From: McConnell, DAVE P <dave.p.mcconnell@lmco.com>
Sent: Monday, February 20, 2017 1:40 PM
To: Grant Robinson
Cc: Hugh Slaney; Thomas Jacobson
Subject: FW: S-92 Central Cover-Conversion to Screws and Nutplates

From: McConnell, David P SIK
Sent: Thursday, April 18, 2013 17:55
To: 'Daryl Dixon' <daryl_d@tasl.co.th>
Subject: S-92 Central Cover-Conversion to Screws and Nutplates

Log Number:	32043
FTR Number:	1068T262
FTR Date:	Oct 23 2008 4:01AM
Aircraft Model:	S-92A
Part ID:	92205-04300-043 CENTRAL COVER ASSY
CSE:	Ivanovich
ATA:	54
Ref Docs:	1) Attached JPEG images
FTR Subject:	Central cover front support modification

McConnell, David P. S-70243
FTR 1068T262 CRM Log ID 32043

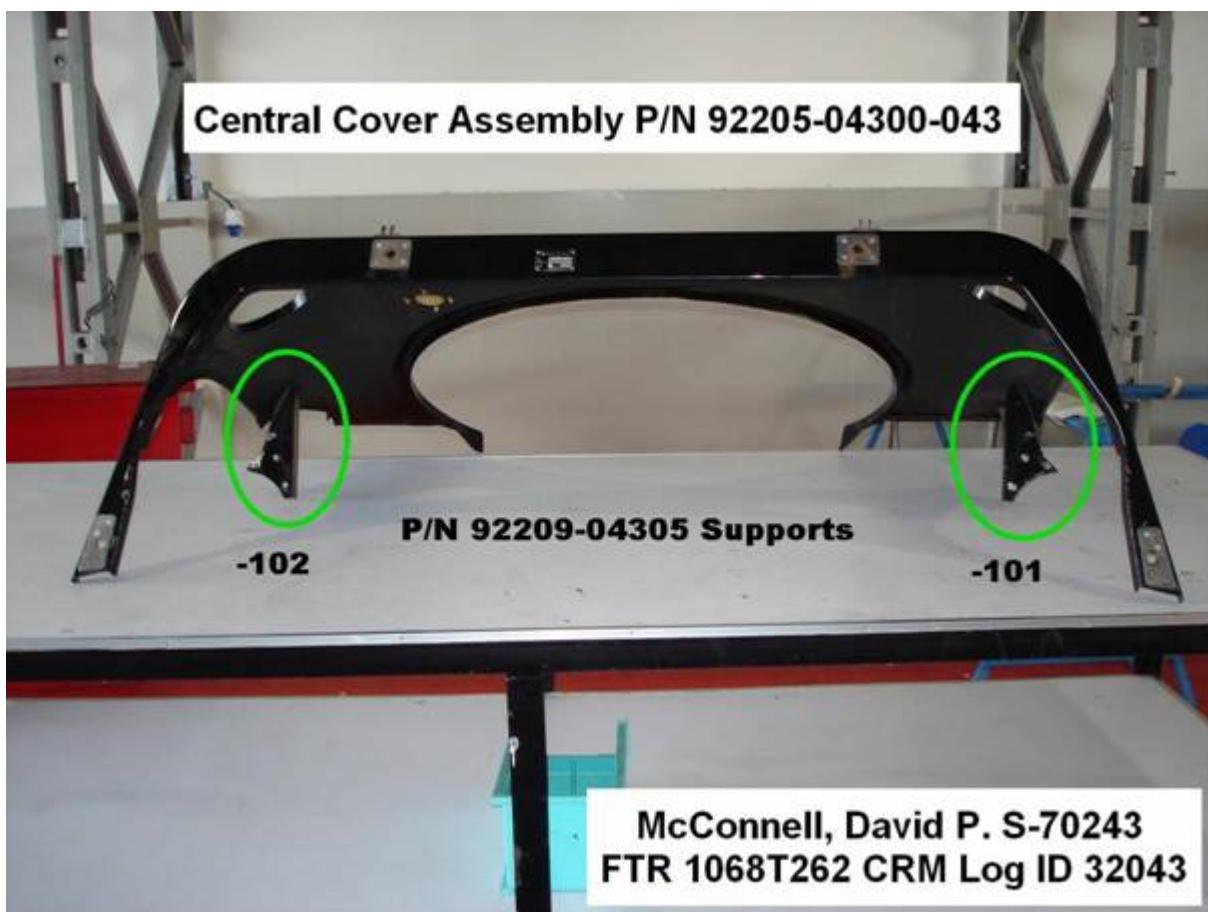
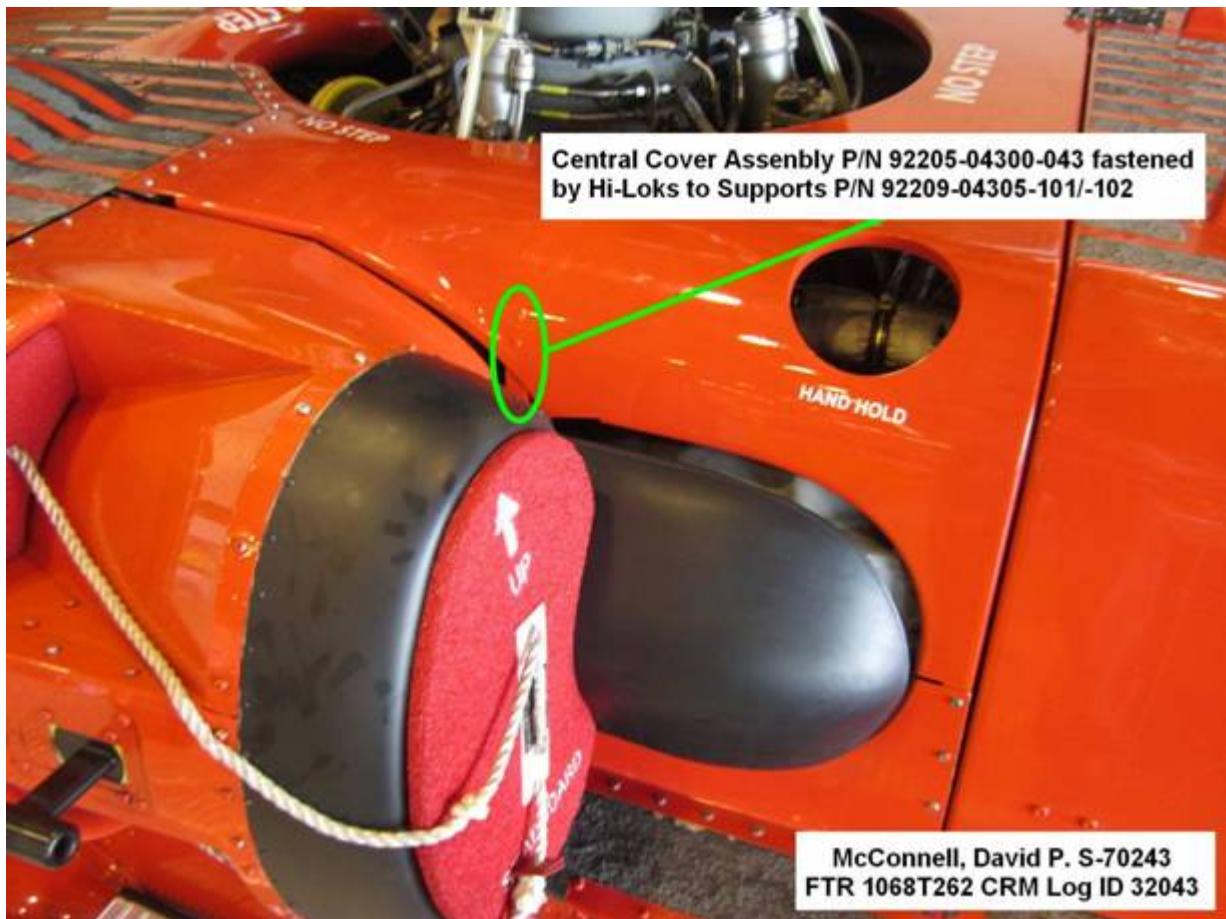
The customer proposes to remove the two P/N HL10VBJ-6-2 Hiloks fastening the upper end of each P/N 92209-04305 upper support to the central cover and replace each Hilok with a P/N TX1004 screw and P/N MS21076 nutplate.

Replace Hi-Loks with
nutplates and screws

Sikorsky Aircraft has no objection to replacing the Hi-Loks on the supports of the central cover with screws and nut plates, and to leave the lower end bolted to the brackets as requested.

McConnell, David P. S-70243
FTR 1068T262 CRM Log ID 32043

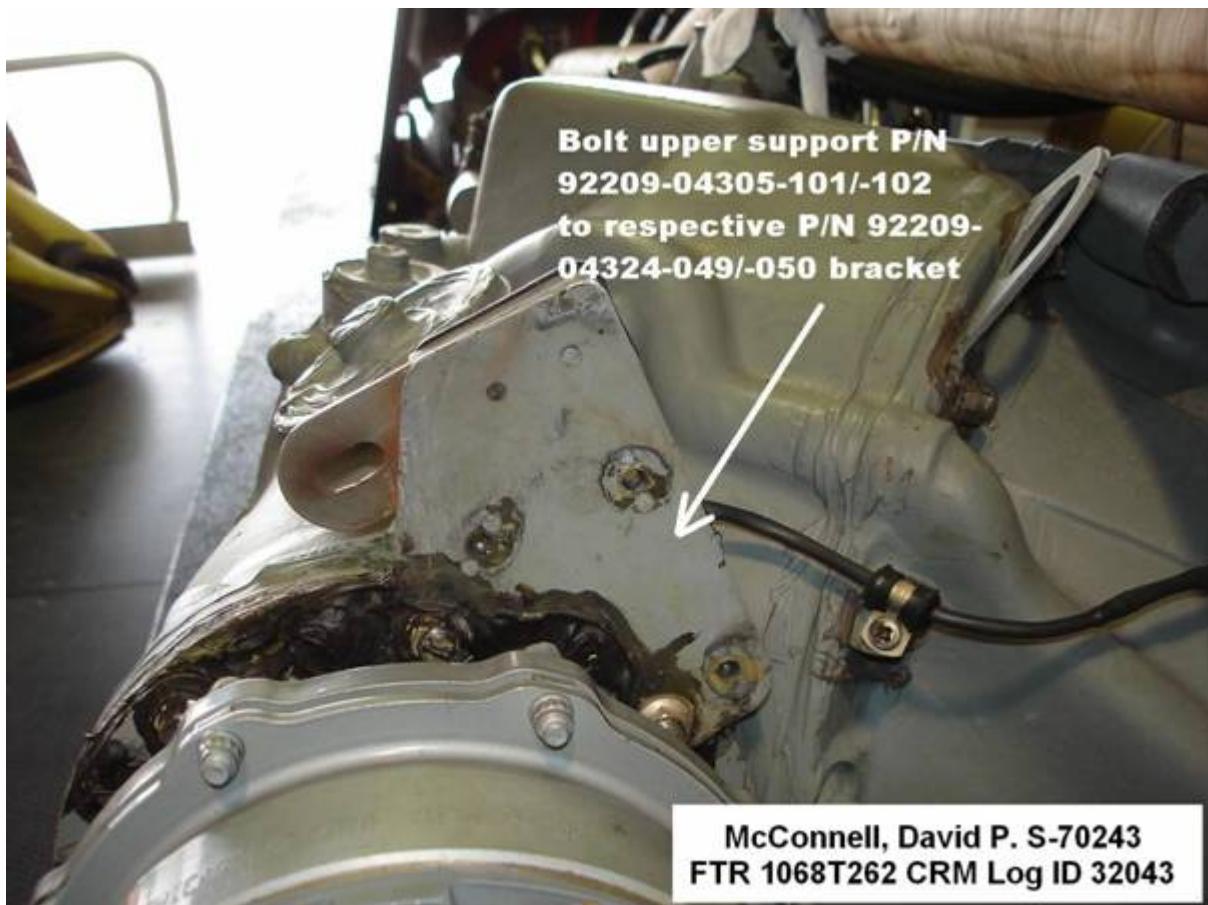
Bolt upper support P/N
92209-04305-101/-102
to respective P/N 92209-
04324-049/-050 bracket
